**Re: Conveyor Amendment**  
**Savage Coal Terminal**  
**ACT/007/022**  
**Carbon County, Utah**

**Enclosed are 3 copies of a proposed conveyor amendment for the Savage Coal Terminal M.R.P. The proposal is to add 3 additional permanent conveyors to transfer coal from the new track loop storage area to the unit train loadout system. It is also proposed to eliminate a portion of the ditch north of the railroad by extending the existing culvert. The proposal is submitted as an appendix for ease of review; however, pertinent pages and maps of the M.R.P. have also been changed to reflect the proposed system.**

**APPENDIX 3-8**

Transfer Conveyor Addition

Figure 3-7

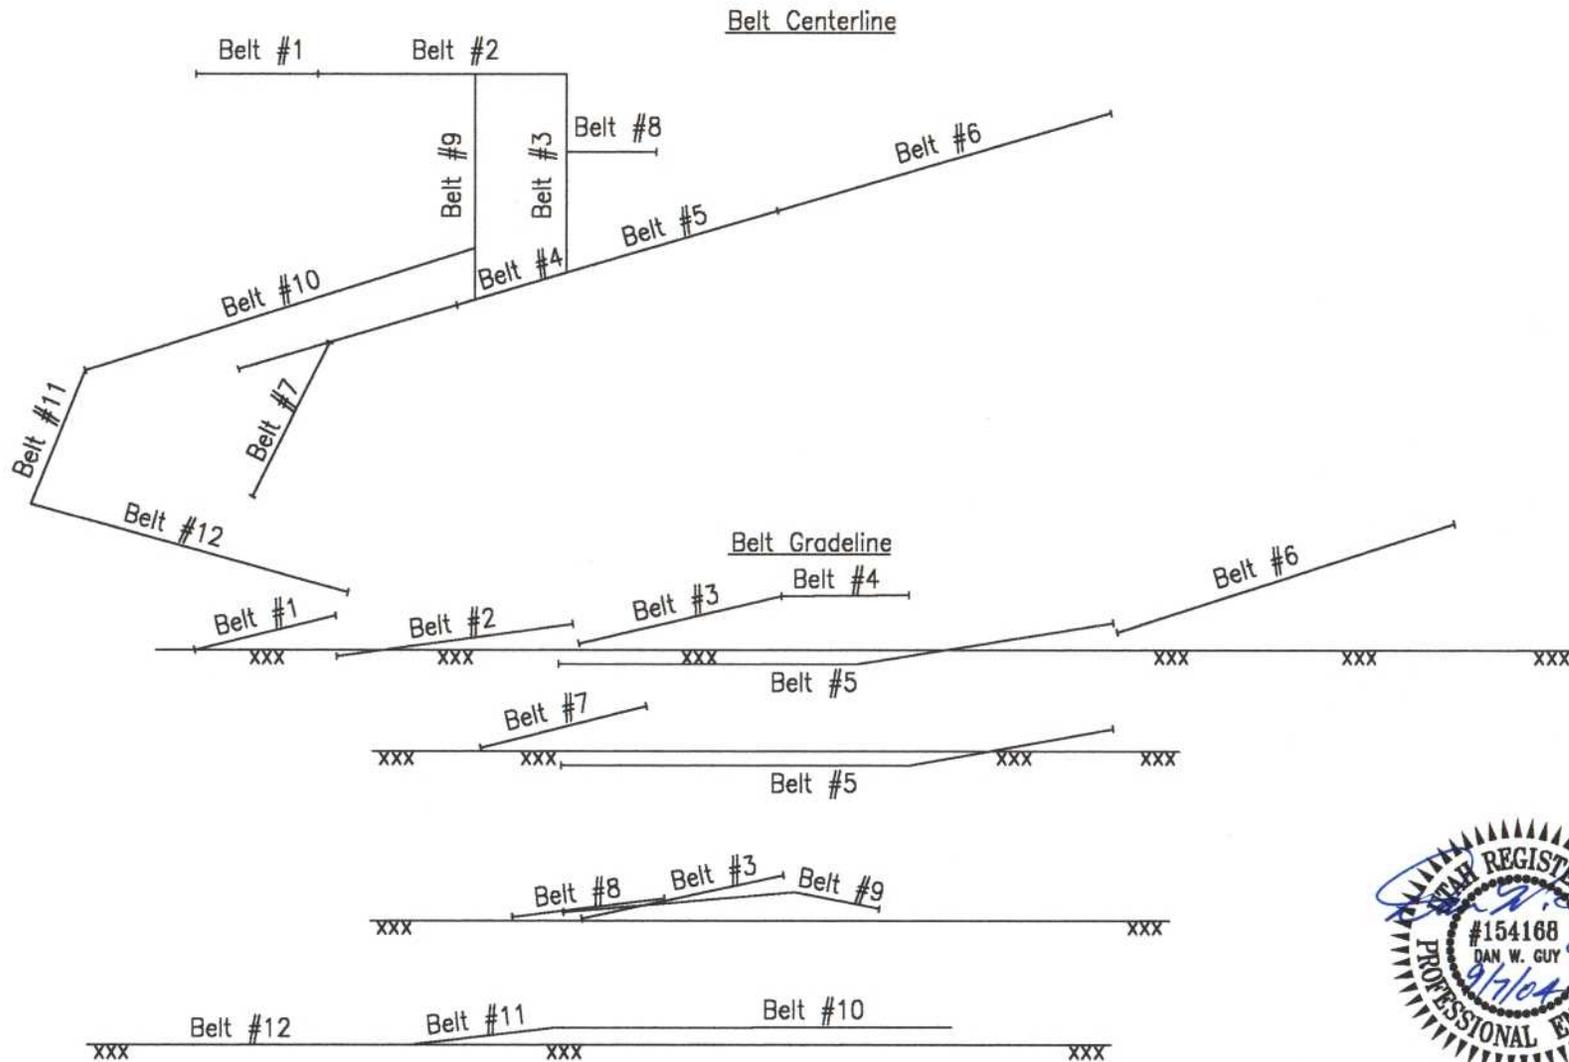
There are **twelve (12)** separate, **permanent** conveyor runs at the C.V. Spur (see Figure 3-7). In addition, there are temporary, portable conveyors used on the site. The number and location of the temporary conveyors varies according to need.

Conveyor #12 - 48" x 564' future surface transfer system to move coal from the track loop storage area to conveyors #10 and #11.

Grade of all conveyors are shown on Figure 3-7, "Conveyors - Loadout & Grades". All surface conveyors are covered and equipped with walkways. All conveyors will be used throughout the C.V. Spur operational life.

SAVAGE COAL TERMINAL  
FACILITY MAP

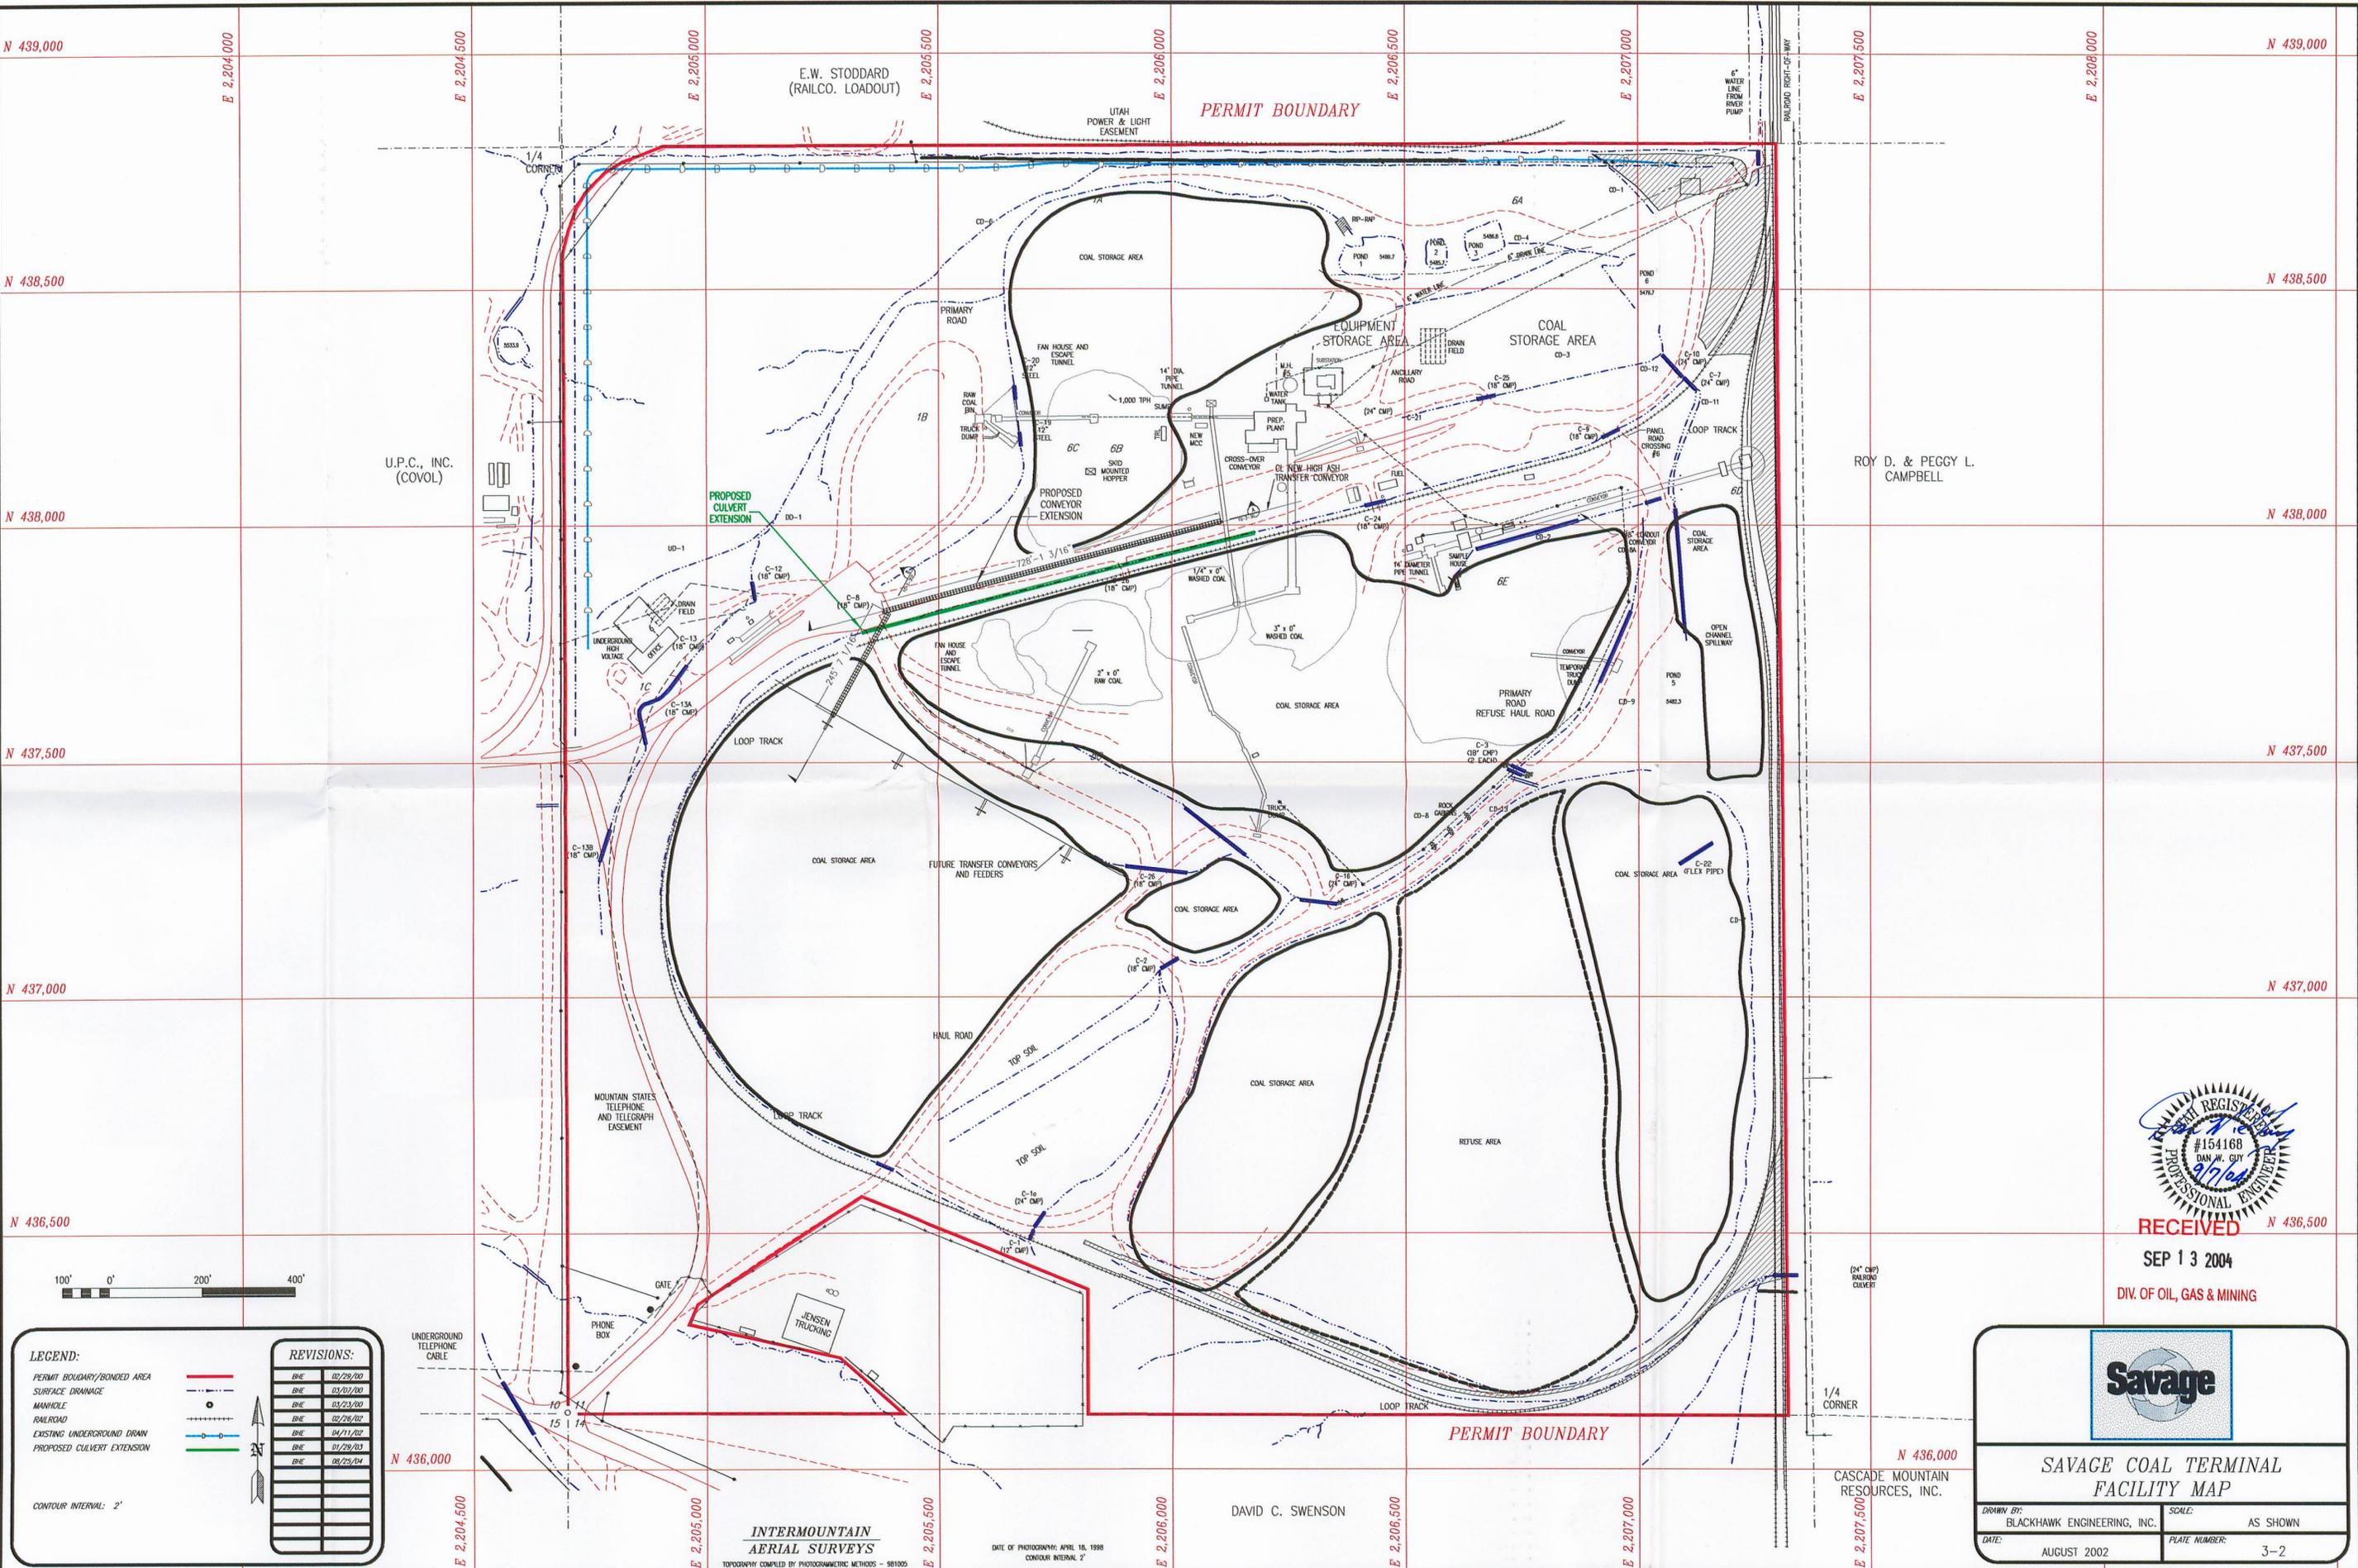
Culvert C-26 will be replaced with extended 18" Culvert C-8.

The only other change to the site plan will be the extension of culvert C-8 for a distance of approximately 800'. This will be an 18" CMP culvert in place of the existing ditch beneath the proposed 728' conveyor. No other drainage controls will be changed as a result of this installation. All construction will be within the existing disturbed area.

The proposed culvert installation is shown on Plate 3-2. Culvert sizing and flow details are shown on Table 7-25, page 7-88a.

A3-8-2

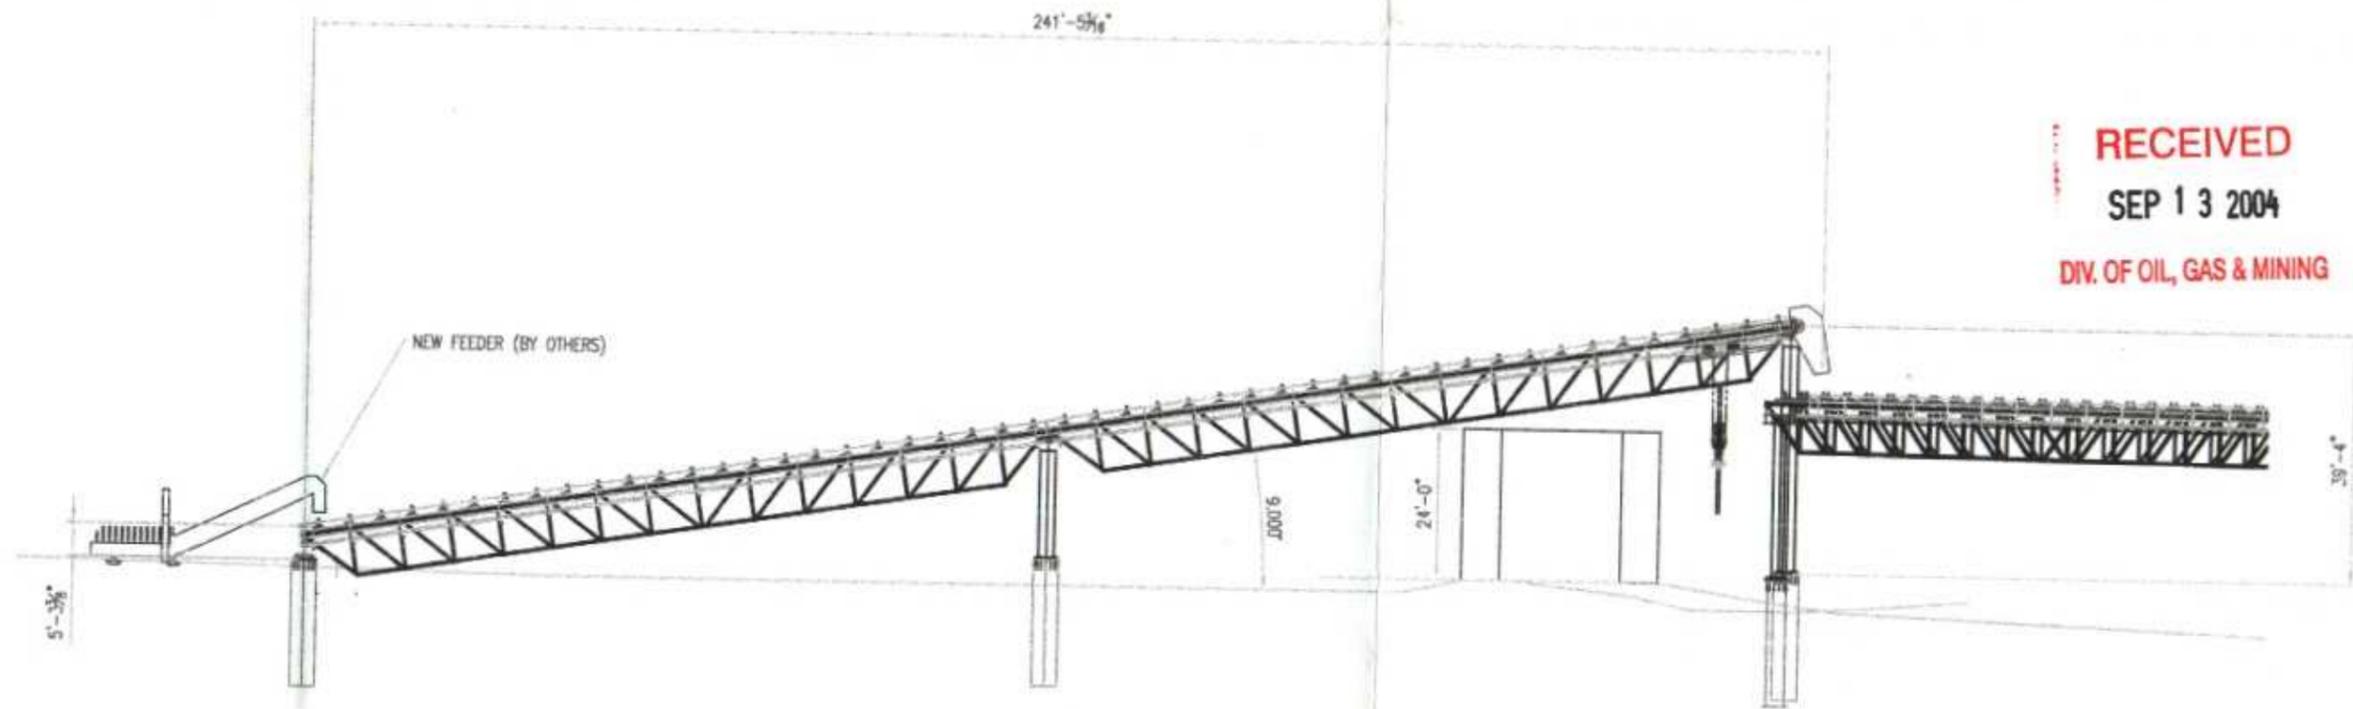
The proposed system consists of 3 conveyors. Two of the conveyors will be elevated, and are approximately 246' and 728' in length, respectively. The third conveyor is a surface transfer system, and is approximately 564' in length. This conveyor is shown as a future installation; however, it is included in this proposal for permitting purposes. Conveyor details are shown on enclosed Plates A3-8-1, A3-8-2, and A3-8-3. All conveyors are 48" wide and will be equipped with covers.
